**STAFF RECOMMENDATION**  
**1822 Ordway Place**  
**October 19, 2016**

**Application:** New construction—addition; Setback determination  
**District:** Lockeland Springs-East End Neighborhood Conservation Zoning Overlay  
**Council District:** 06  
**Map and Parcel Number:** 08310024700  
**Applicant:** Kaitlyn Smous  
**Project Lead:** Melissa Baldock, melissa.baldock@nashville.gov

**Description of Project:** Application is to construct a rear addition. The application includes reducing the right side setback from ten feet (10') to approximately two feet (2').

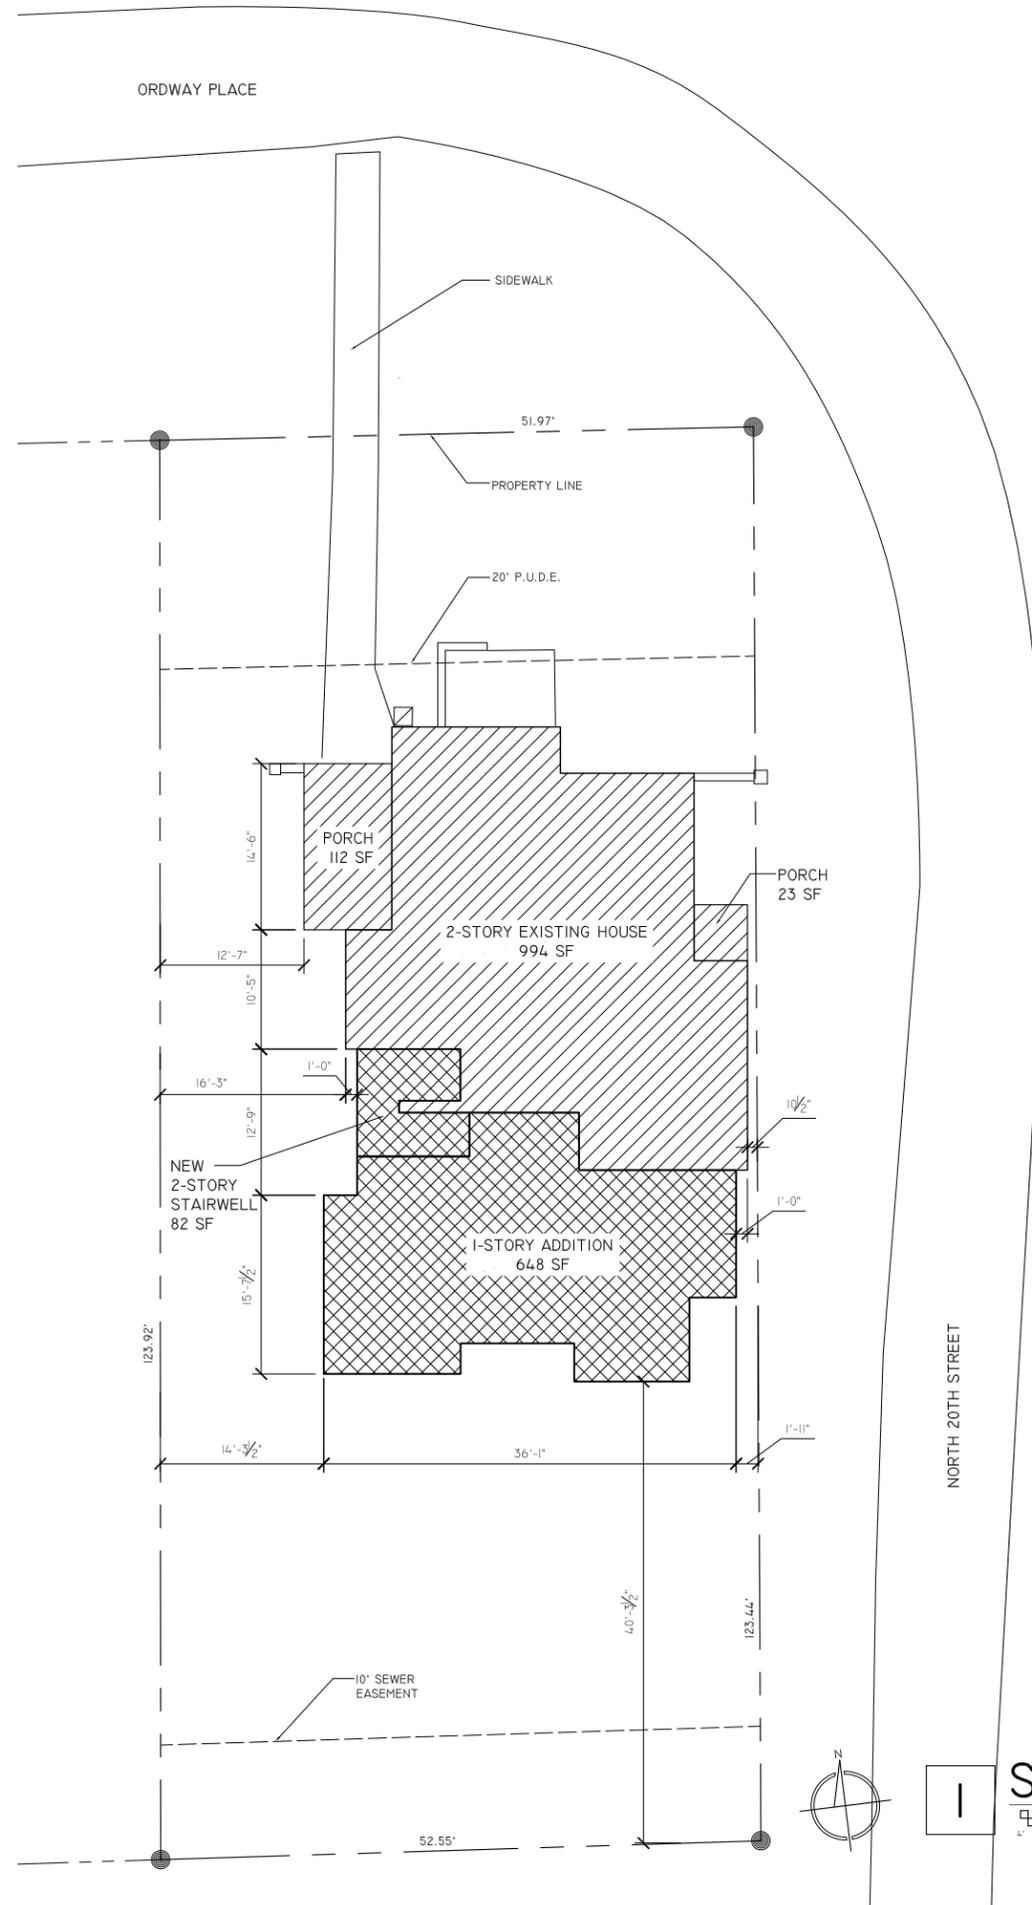
Proportion and Rhythm of Openings: The changes to the window openings on the historic house were discussed under "Partial Demolition."

The windows on the proposed addition are all generally twice as tall as they are wide, thereby meeting the historic proportions of openings. There are no large expanses of wall space without a window or door opening. Staff finds that the project's proportion and rhythm of openings meet Sections II.B.7. and II.B.10. of the design guidelines.

**2 SOUTH ELEVATION**  
 SCALE: 1/8"=1'-0"  
 2' 1" 0 2' 4" 0 8" 12"

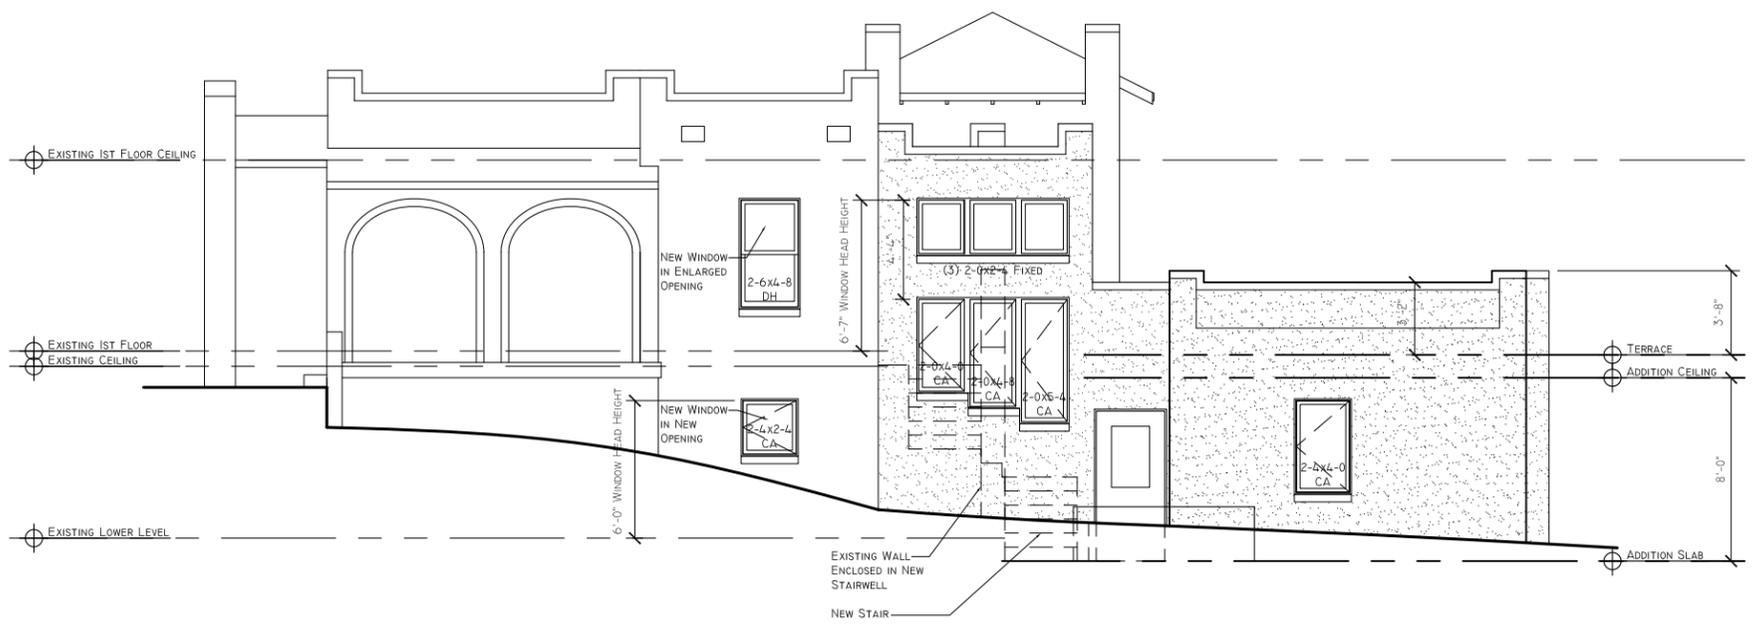
On the left elevation, the applicant seeks to alter an existing window opening at the basement level towards the back corner of the house (Figure 6). The existing single window will be enlarged to a custom arched window unit to fill the existing arch (Figure 7). A photograph from 1986 shows that this arched area and the arch next door to it used to have larger windows or French doors in them (Figure 8). The existing window configuration therefore dates to after 1986, and altering it is appropriate. However, staff recommends that the new window better replicate the design of what is shown in the 1986 photo.

Appurtenances & Utilities: No changes to the site's appurtenances were indicated on the drawings. The location of the HVAC and other utilities was also not noted. Staff asks that the HVAC be located on the rear façade, or on a side façade beyond the midpoint of the house.

1. The design of the new arched window on the North Twentieth Street façade replicate the design seen in the 1986 photograph;
2. Staff approve the final details, dimensions and materials of the left façade storage door doors prior to purchase and installation; and,
3. The HVAC shall be located behind the house or on either side, beyond the mid-point of the house.
